<b>PART 3 – SITING THE DEVELOPMENT</b>	
<b>Development objectives</b>	<b>Assessment/Comment</b>
<p style="background-color: #f4a460; color: white; padding: 5px;"><b>Objective 3A-1</b></p> <p style="background-color: #f4a460; color: white; padding: 5px;">Site analysis illustrates that design decisions have been based on opportunities and constraints of the site conditions and their relationship to the surrounding context</p> <hr style="border: 1px solid #f4a460;"/> <p style="background-color: #f4a460; color: white; padding: 5px;"><b>Design guidance</b></p> <p style="background-color: #f4a460; color: white; padding: 5px;">Each element in the Site Analysis Checklist should be addressed (see Appendix 1)</p>	<p>A site analysis has been submitted with the subject application which identifies the constraints and opportunities of the site</p> <div style="text-align: center;">  </div>
<p style="background-color: #f4a460; color: white; padding: 5px;"><b>Objective 3B-1</b></p> <p style="background-color: #f4a460; color: white; padding: 5px;">Building types and layouts respond to the streetscape and site while optimising solar access within the development</p> <hr style="border: 1px solid #f4a

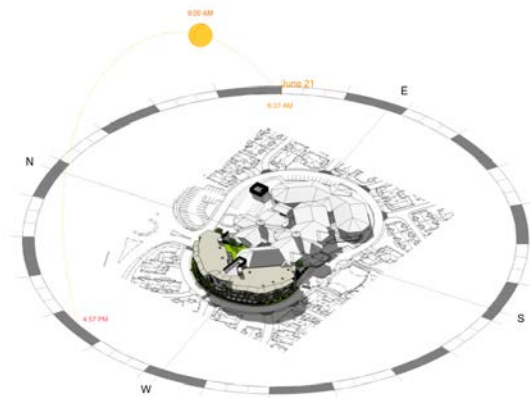
This section of the ADG advises that the subject application is required to provide solar access in accordance with 3D and 4A. The proposed development is considered to comply, please refer to these sections of this assessment for a full assessment.

Notwithstanding the following table includes a breakdown for the proposed apartments (Levels 2 and 3)

TOTALS	
TOTAL SELF CONTAINED DWELINGS	36
TOTAL COMPLIANT	27
TOTAL NON-COMPLIANT	9

COMPLIANCE 9AM - 3PM (3 HOURS)	REQUIRED FOR COMPLIANCE PERCENTAGE OF COMPLIANT APARTMENTS	70% 75%
-----------------------------------	---	------------

WINTER SOLAR ANALYSIS - 21 JUNE 9AM

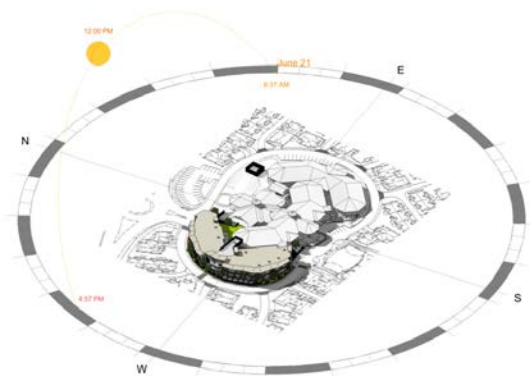
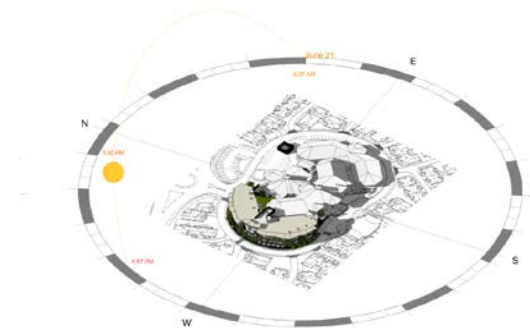
The solar access to living rooms, POS areas and balconies of adjoining properties is considered minimal. From the submitted shadow diagrams – the following is applicable at 21 June.

It is considered that any adjoining dwellings which benefit from Solar will not be affected, the site is irregular in shape, and however it is generally considered that the building is oriented 90 degrees to the boundary. The adjoining properties are separated from the proposed development by the internal access road; this separation has decreased the potential overshadowing impacts.

**LANDSCAPE DATA :**

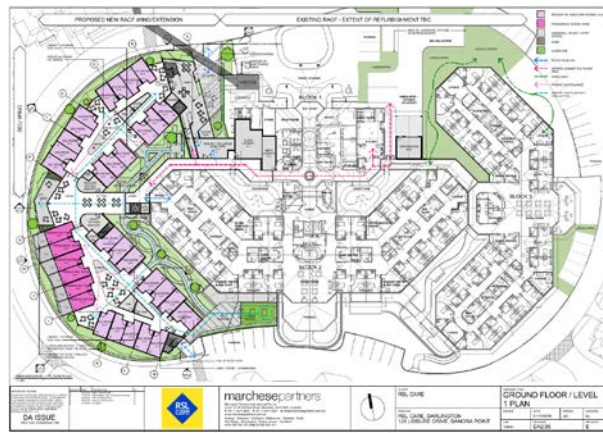
The subject site when viewed in its entirety is compliant with the requirements.

The site includes 2488sqm; which equates to approximately 12%.

Of this area, there are three sections which comply with the minimum area of 6m x 6m; two of which include existing mature trees.

The area between the existing building and the proposed building includes an area the length of the development x 6m, the application seeks to include planting trees within this area, which will provide adequate shading.

All existing vegetation onsite is proposed to be retained. The development footprint is currently comprised of grassed area.

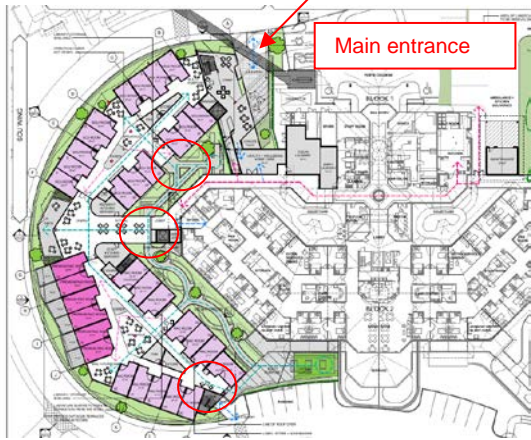
The proposed development at ground level does not include POS areas for units 18-33 (Special Care and Residential Aged Care), where these areas adjoin communal spaces. These rooms are proposed to include glazed windows to allow viewing of the communal areas, without jeopardising the privacy of these units. Notwithstanding this, the units at ground level are not defined as apartments under this SEPP.

The proposed development also includes:  
 Landscaping;  
 Planter boxes;  
 Louvres;  
 Screens etc

See indicate image below.
